### **On-Property Corrective Measures Implementation Construction Completion Report**

Subject:  
On-Property CMI Construction Documentation Report  
Koppers Inc. Superior, Wisconsin Facility  
WDNR BRRTs No: 0216000484  
WDNR Facility ID: 816009810

**On-Property Corrective Measures  
Implementation Construction  
Documentation Report**

Koppers Inc. Facility  
Superior, Wisconsin

10 ft

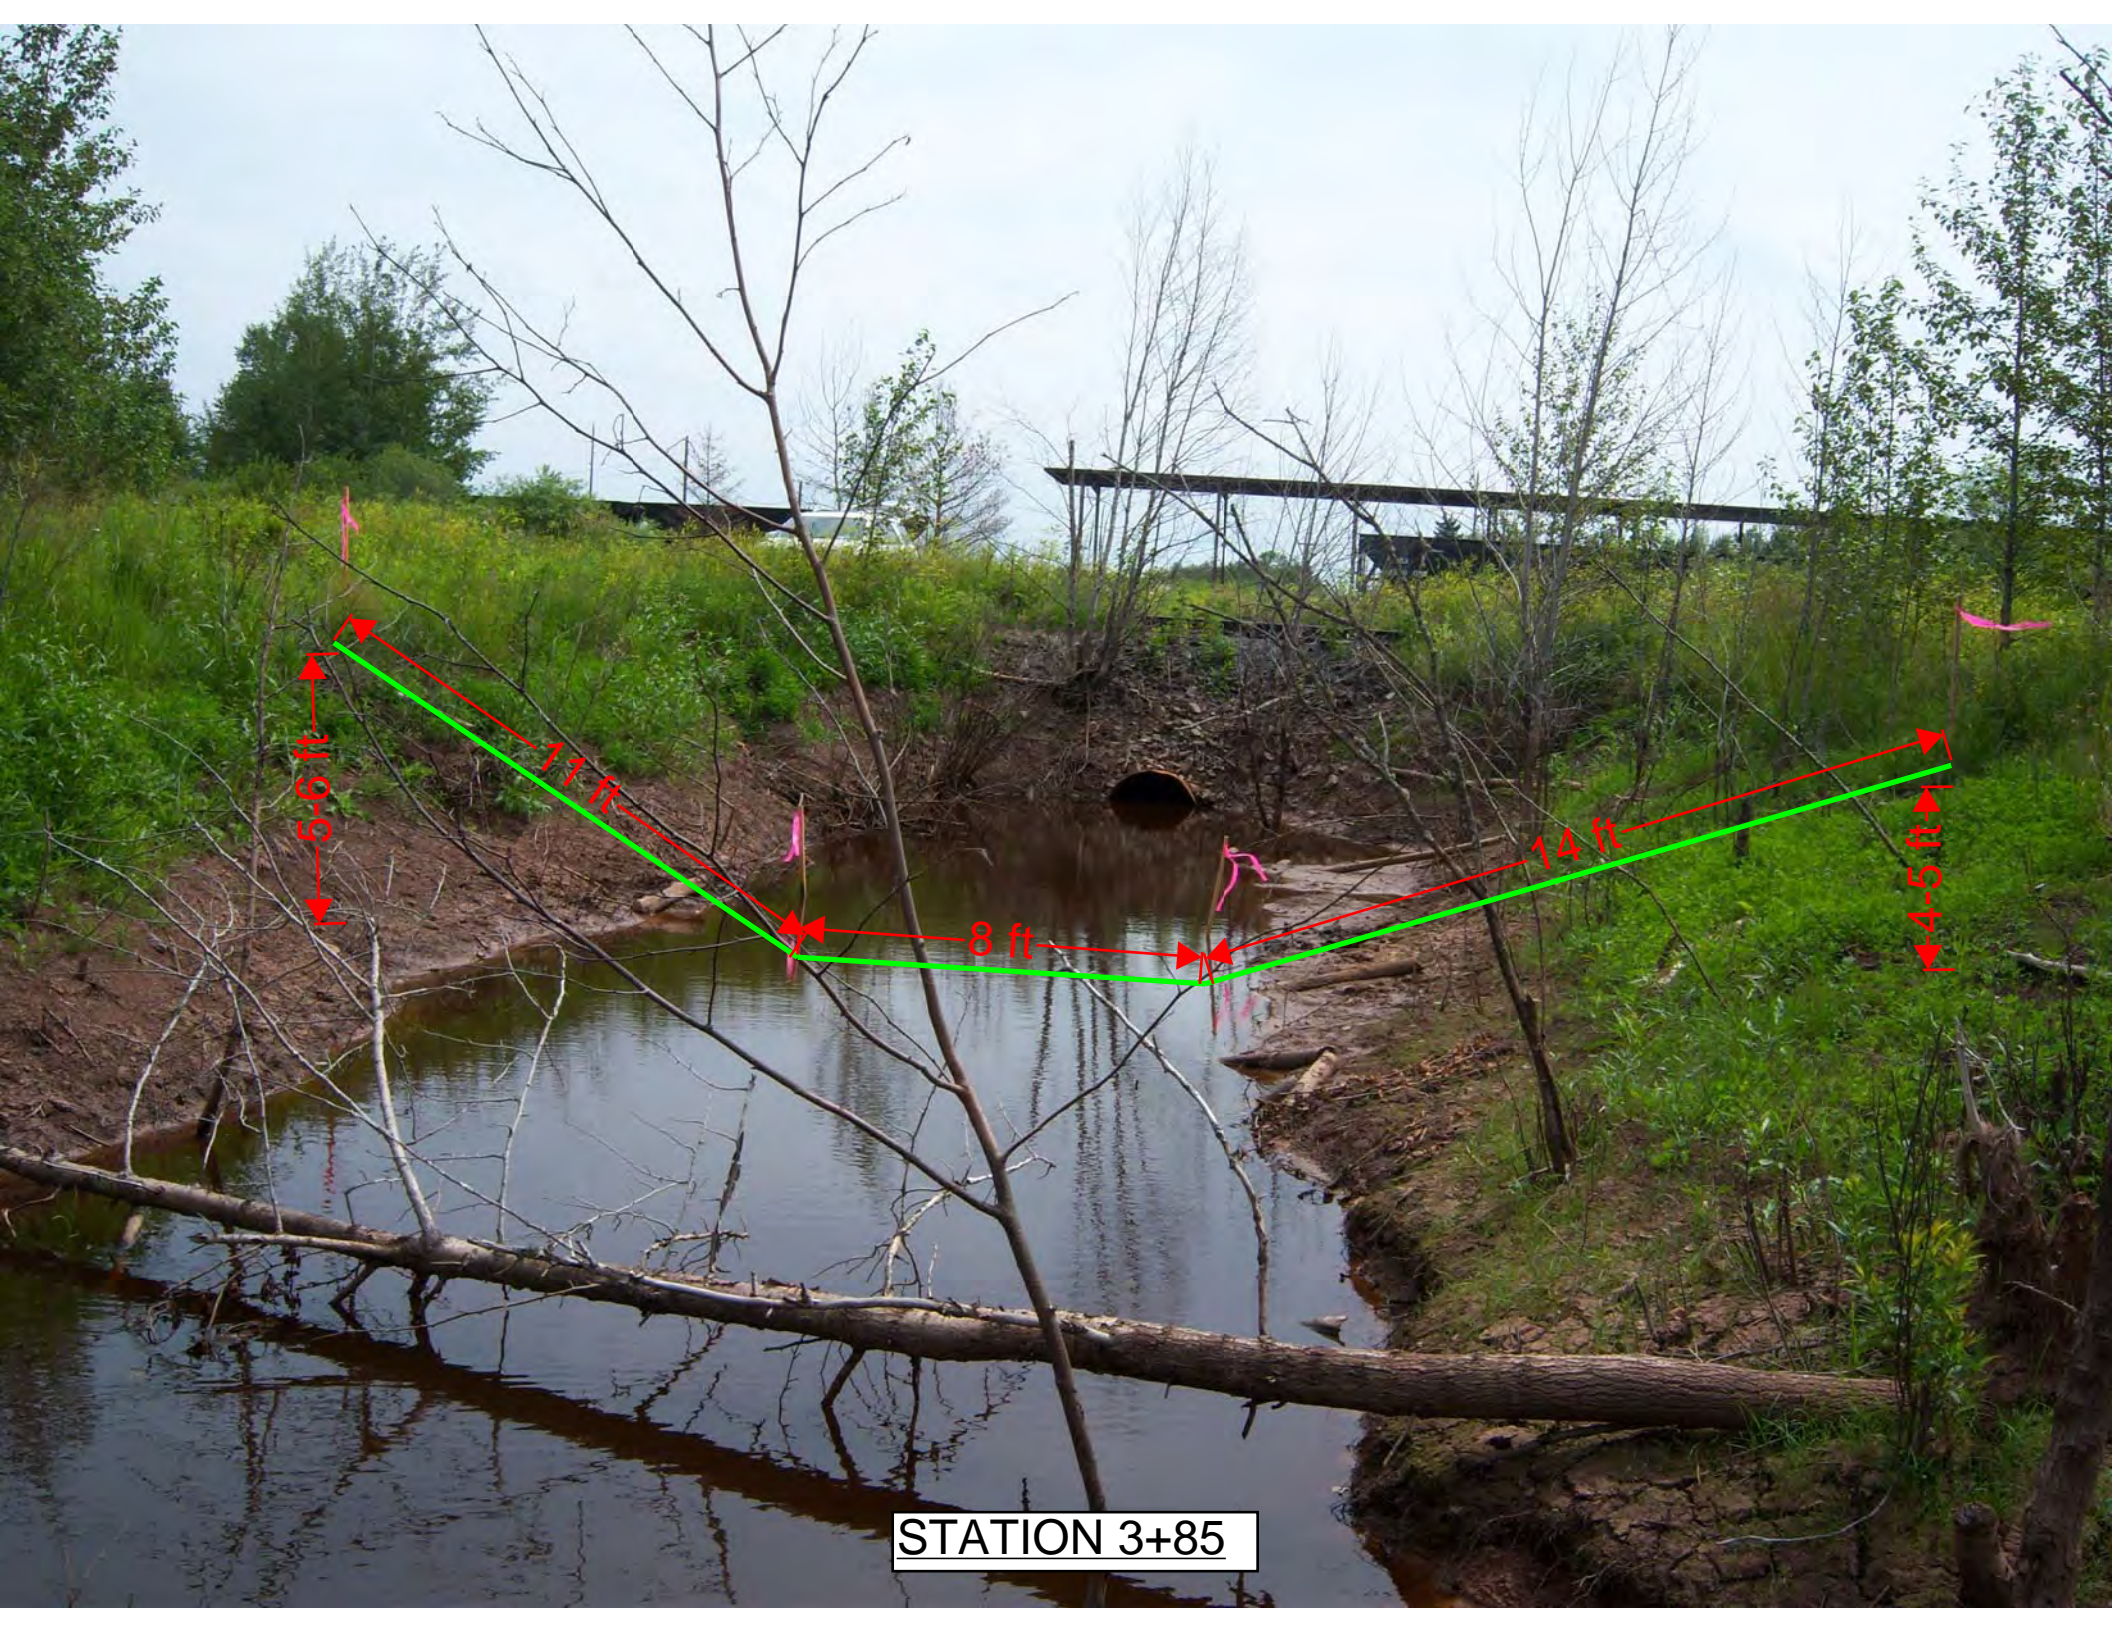
As discussed during the June 11, 2010 meeting at Severson's office in Delmont, Pennsylvania, due to high water in the Outfall 001 drainage ditch during the pre-design survey, the surveyor was unable to record the existing channel geometry. The typical on-property channel cross-sections depicted on Contract Drawing C301, which represent the minimum restored channel dimensions required to maintain proper Facility drainage, were used by Severson to determine the necessary quantities of the Outfall 001 drainage ditch restoration materials for their "Gray Book" Project Cost Estimate (Gray Book). Because the channel should not be filled with additional materials to achieve the minimum dimensions shown on Contract Drawing C301, the quantities of Outfall 001 drainage ditch restoration materials included in the Gray Book are potentially less than the actual required restoration material quantities. As an alternative to hiring a surveyor to conduct an additional survey of the Outfall 001 drainage ditch during lower-water conditions so that the restoration material quantities could be verified, Beazer decided to increase the Outfall 001 drainage ditch restoration material quantities by 30%.

During a July 13, 2010 site visit by ARCADIS, it was noted that the Outfall 001 drainage ditch water levels were low and the actual existing channel geometry at three locations was recorded. Photographs of these three transects and the existing channel dimensions are included as Attachment 1. As shown in Attachment 1, the existing channel dimensions, and therefore the restored channel dimensions, are increased from than the typical on-property channel cross-sections depicted on Contract Drawing C301.

ARCADIS calculated the quantities of all Outfall 001 drainage ditch restoration materials. The following table compares the quantities included on Contract Drawing C100 and the "Estimate Worksheet – Outfall Drainage Ditch Restoration" of the Gray Book with the estimated required quantities based on the existing channel geometry measured on July 13, 2010:

<b>Material</b>	<b>C100 Quantity</b>	<b>"Gray Book" Quantity</b>	<b>Revised Quantity</b>
Pea Gravel	--	390 ton	306 cy <sup>1,2</sup>
Reactive Core Mat	--	1,850 square yards (sy)	2,377 sy <sup>3</sup>
General Fill	--	240 cy	344 cy
Non-Woven Geotextile	--	20,800 square feet (sf)	28,405 sf <sup>3</sup>
R3 Riprap	900 cy	1,170 ton	915 cy <sup>2</sup>

**C200**

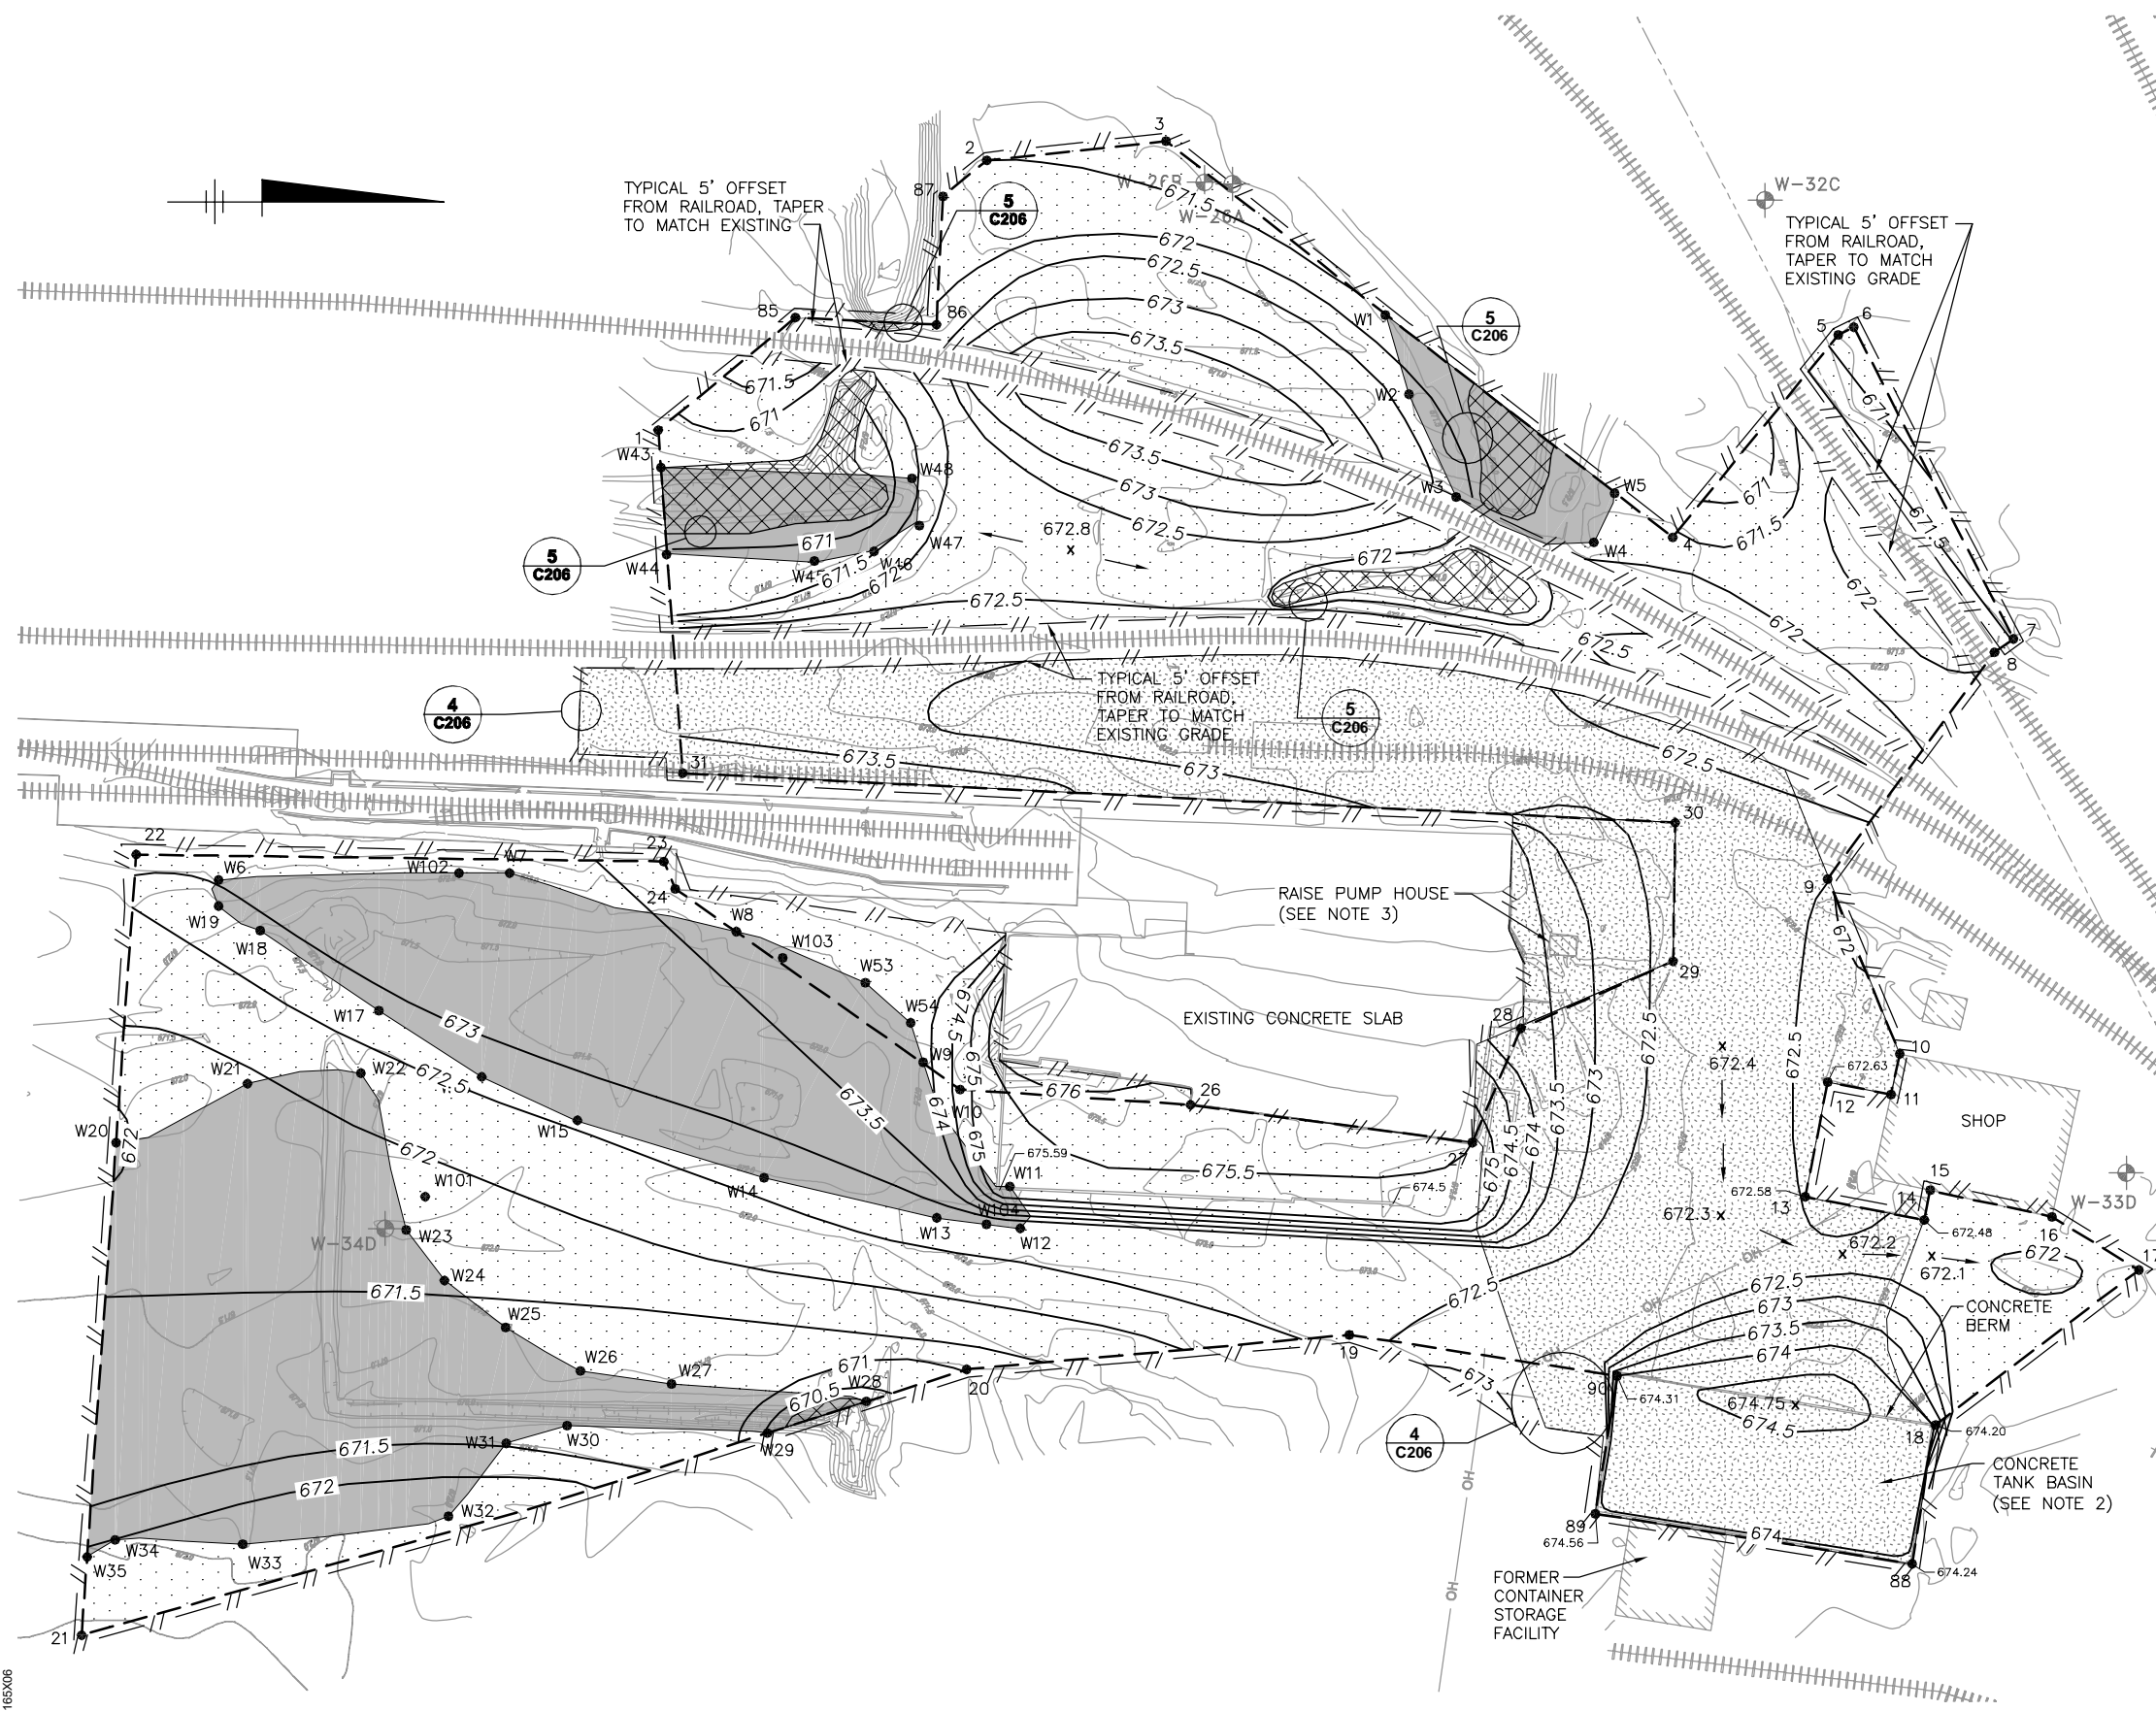
Attached is revised Contract Drawing C200 for the final revised grading plan for Area B based on the adjusted Limit of Grading to include the pump house building area and 2010 ground survey data<sup>1</sup>.

<sup>1</sup> Cross-sections A, B and C (included on Contract Drawing C201) were not revised for this Field Order No. 004 submittal.
